MEMORANDUM

To: The Design Advisory Board
From: Mary O'Neil, AICP, Associate Planner
RE: ZP 12-0014 CA 26 Grove Street
Date: August 23, 2011

Request: 20' x 20' three story addition on the back of an existing single family house; remove lower driveway, extend upper driveway to accommodate 2 cars, remove collapsed garage.

Proposed Site Plan

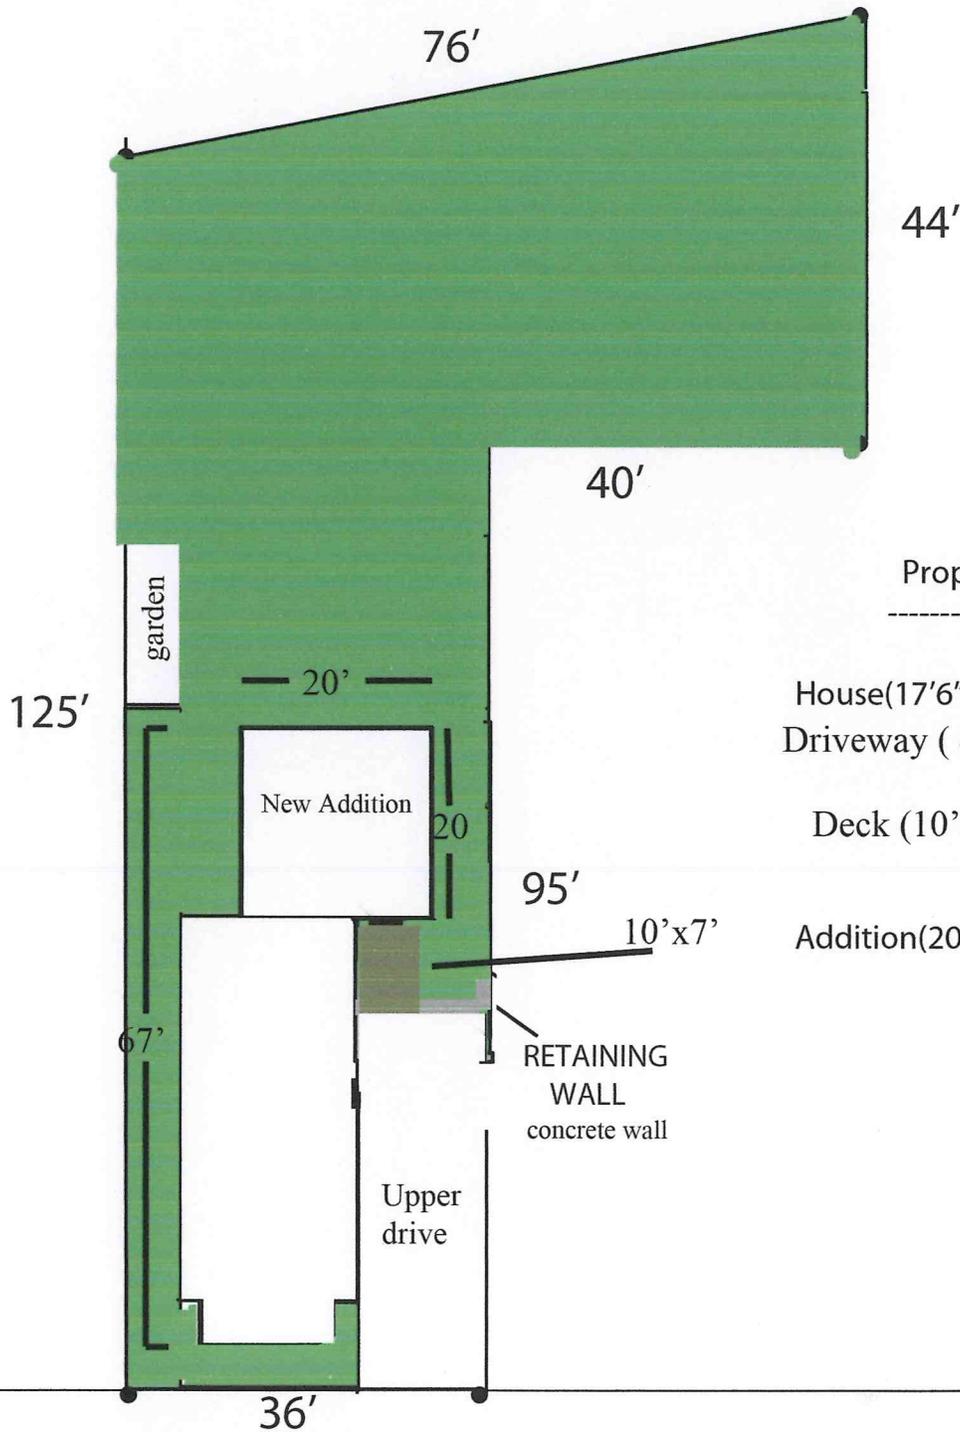
Two entrance doors are proposed for the front of the building: One entering an existing enclosed porch, another into the proposed addition off a new deck. No sidewalks or walkways are illustrated on the submitted site plan.

The parking requirement must be met as additional living space is proposed. The applicant proposes to extend the driveway to allow for the full 40' length for 2 parking spaces (9' x 20' each); however it is not clear where the public ROW ends and the parcel boundaries begin. Without an accurate survey and definition of the property boundaries, any estimation is conjectural.

1. An accurate survey of the property, including boundary lines and existing setbacks to assure no encroachment into required setbacks and onto adjoining properties. A revised site plan shall be submitted with **accurate** measurements, including existing setbacks, driveway measurements, and boundary lines.

Proposed Ground Contour + Erosion Control Plan

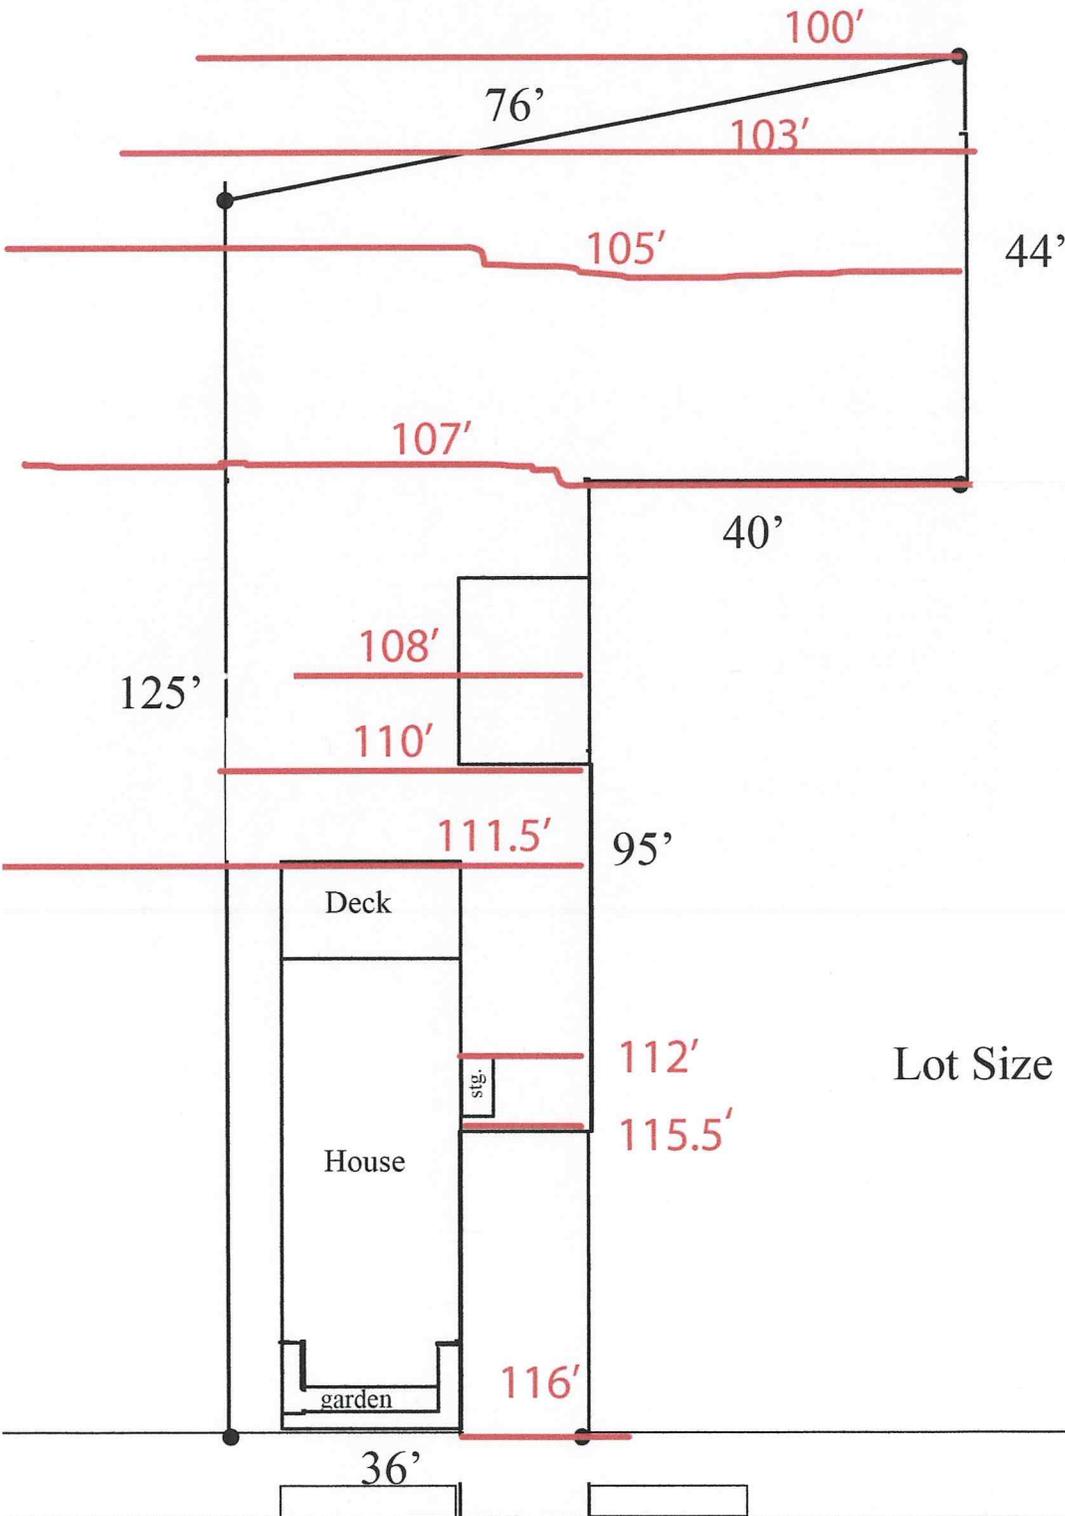
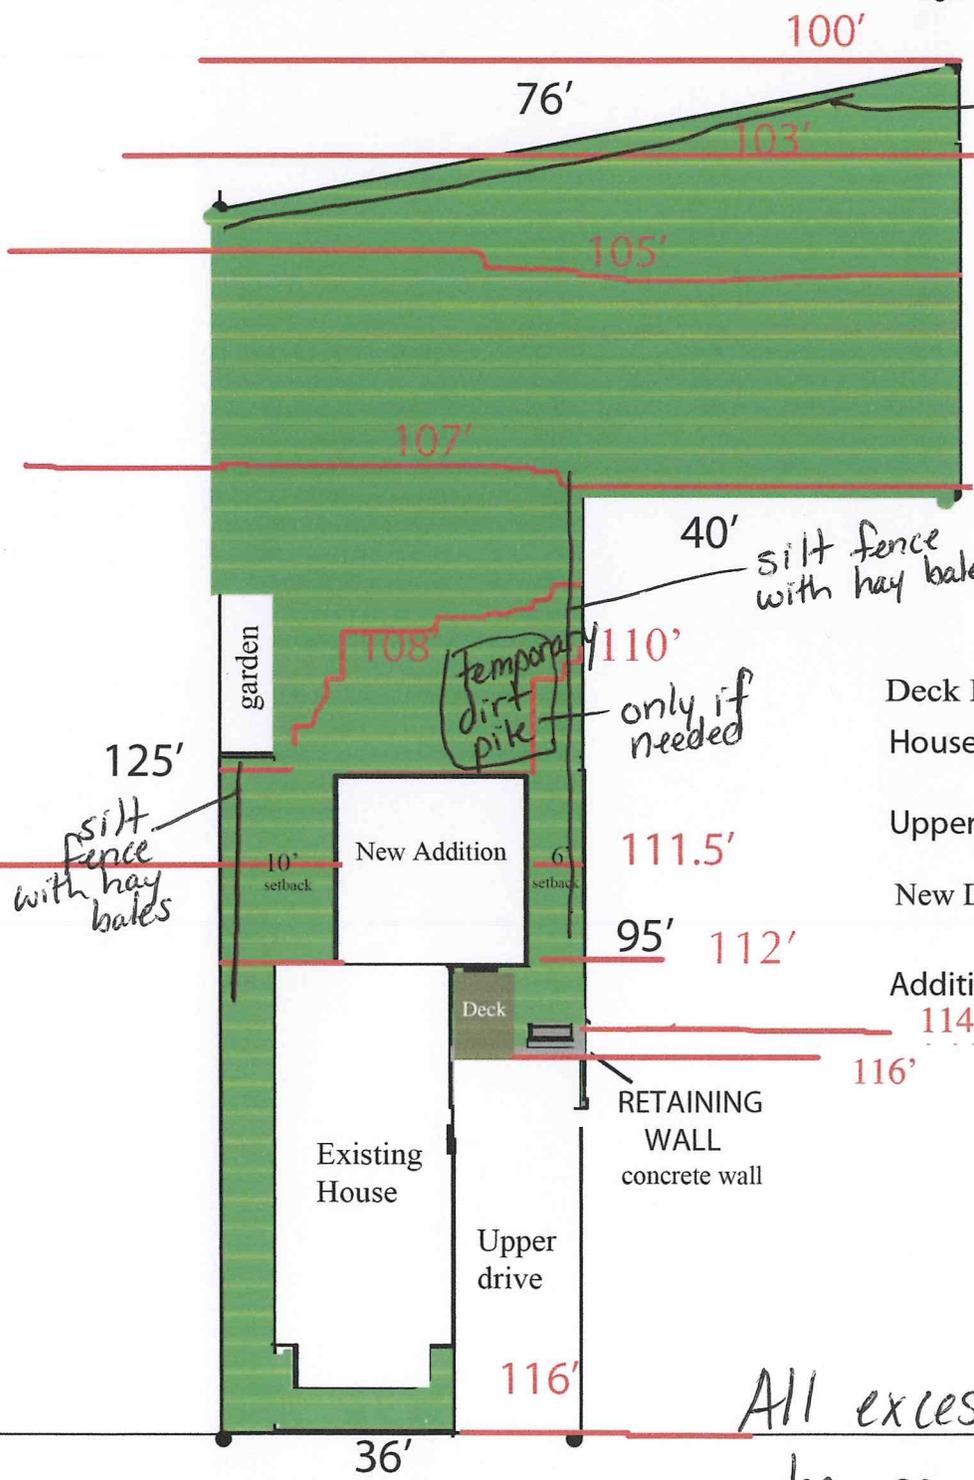
The site drops approximately 16' from front to back; a relatively precipitous change of grade in which to plan a building addition of this scale. Contour and site plans are not professionally prepared, and by the applicant's admission, contour lines and measurements are arbitrary. In order to adequately understand the challenges of the proposal and implications for this site and neighboring properties, professional engineering and topographical plans are needed, especially given the significant grade changes.

As the plans are not professionally prepared nor the drawings scaled and assuredly accurate, it is difficult to discern how the driveway extension will be supported and how grade changes may impact this and surrounding properties. Additionally, detailed plans for the proposed retaining wall/stair system have not been submitted. Due to the grade and contour changes proposed, and the size of the structural addition, more professional plans are needed prior to continuing review. Any retaining walls greater than 3' which is possible given the parking plan, must be reviewed by the City engineer.

2. An engineers plan is needed to discern accurate topographic contours, proposed grading changes, and structural requirements for the retaining wall, driveway build-up and extension, and site alterations proposed within the application.

West Elevation
(FRONT)

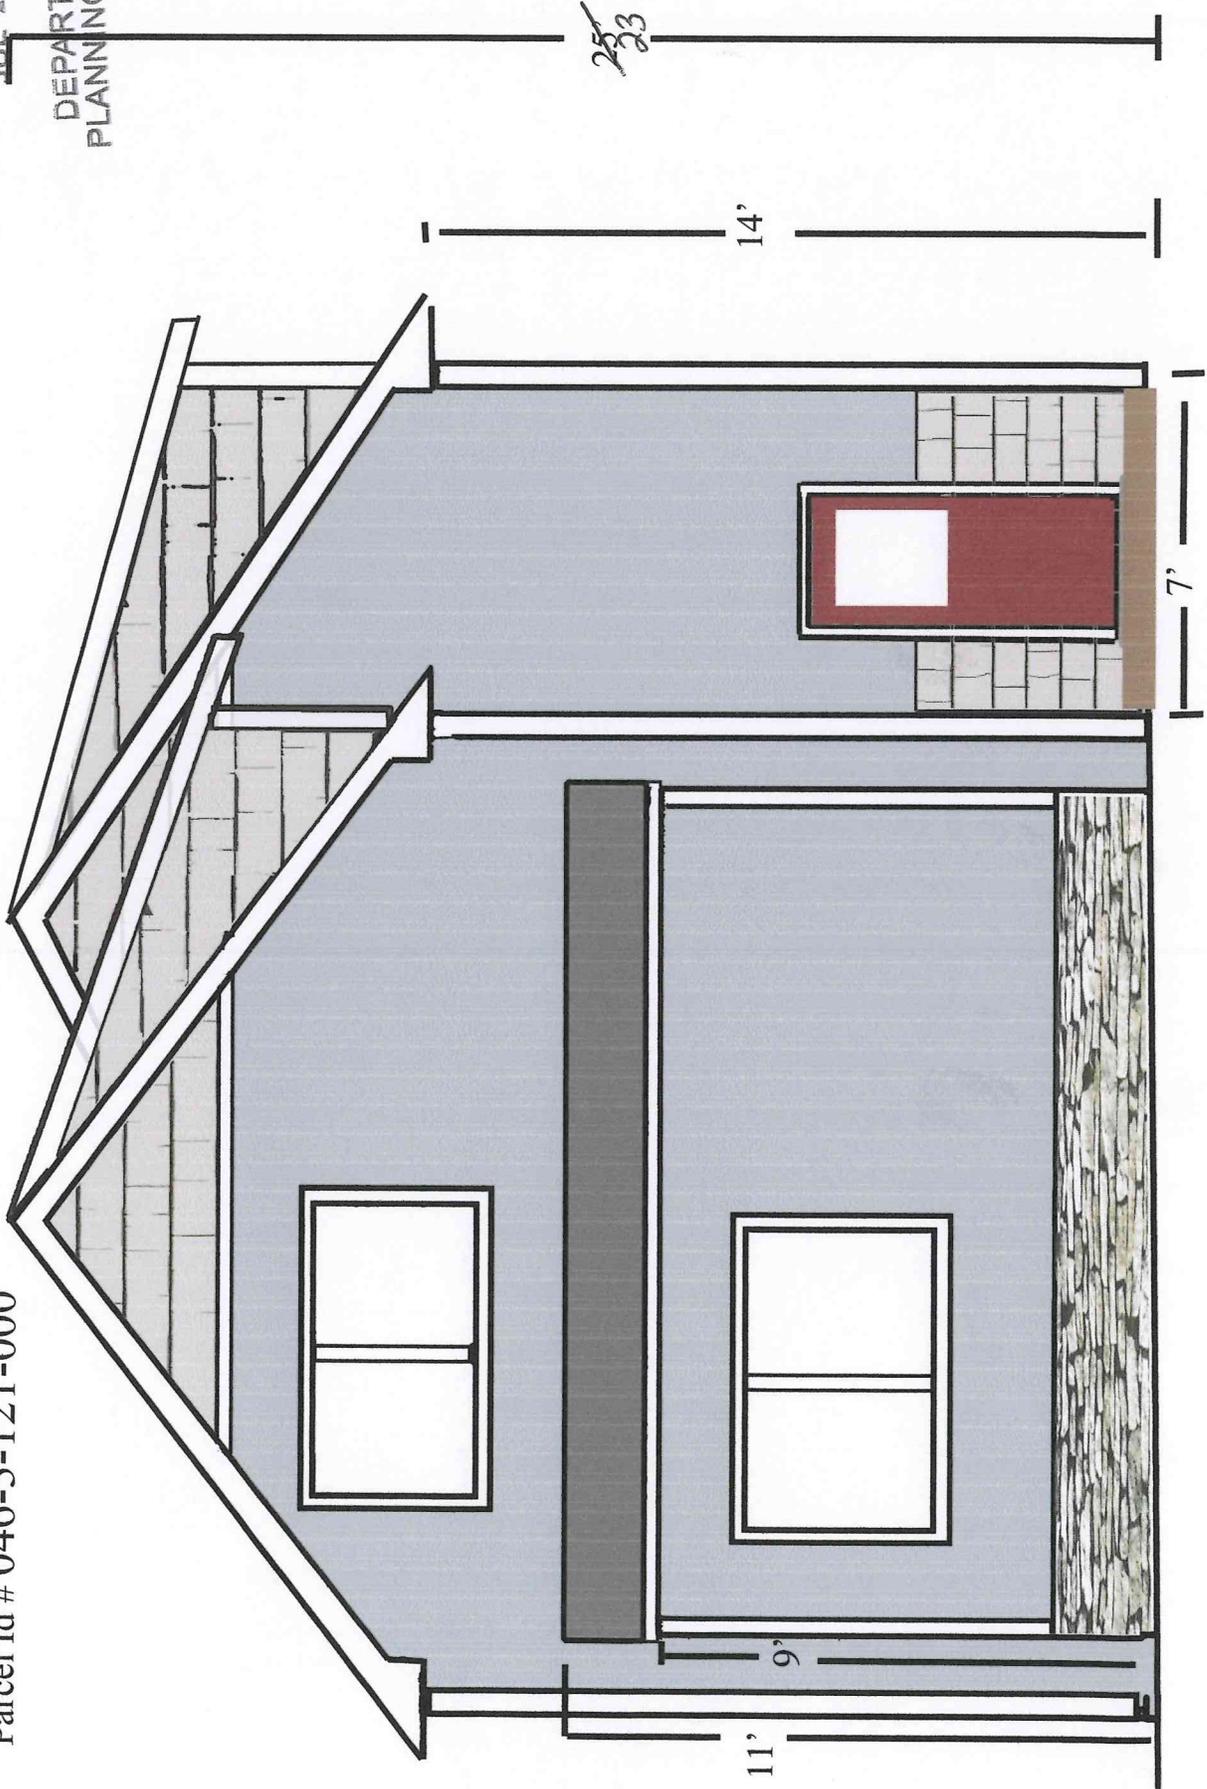
The front façade of the new addition offers little to recommend itself to the passers-by; the wall is stark but for the puncture of an entrance door and a modicum of shingles. Some greater design gesture should be incorporated (porch canopy or entrance porch; lighting, additional windows, particularly on the upper floors) to warm up this rather dreary and uninspired building front.

Elevation call-outs say “Vinyl siding 3’ clapboard.” Cedar shakes are identified as a detail, however it is not clear if that is true cedar, or a composite siding replica. The applicant needs to identify what specifically is proposed for exterior sheathing. Vinyl windows and asphalt roofing indicate common, inexpensive building components, some of which are not likely to have an extended, attractive or durable life.

East Elevation

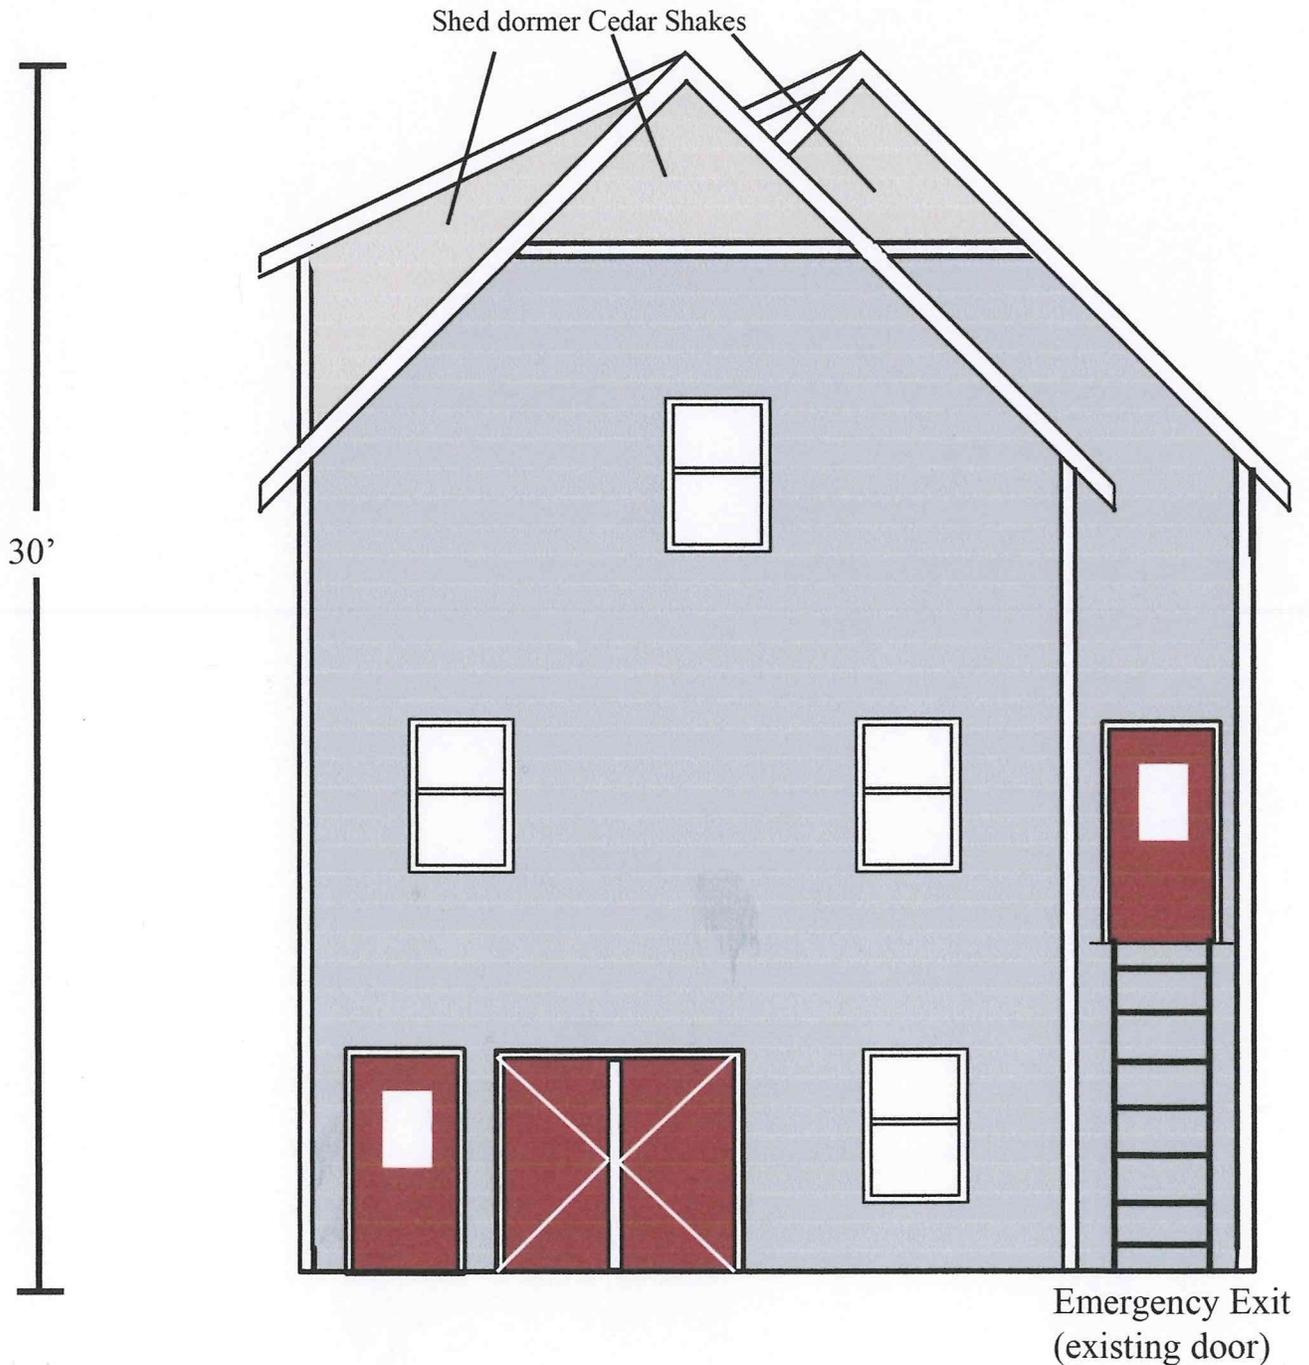
Four entrance doors are proposed; one existing at the enclosed front porch; another into the new addition from the front deck, and two on the rear (east?) elevation plus a garage door at the rear. The

proposed stairway/steps from the rear exit appear to encroach within a side yard setback, although without an accurate survey it is difficult to discern. The rear “emergency exit” doorway is accessed by a stairway – with no details as to the stairway or railings are provided. Single family homes do not typically require an emergency egress door, so the labeling and intent are unclear.
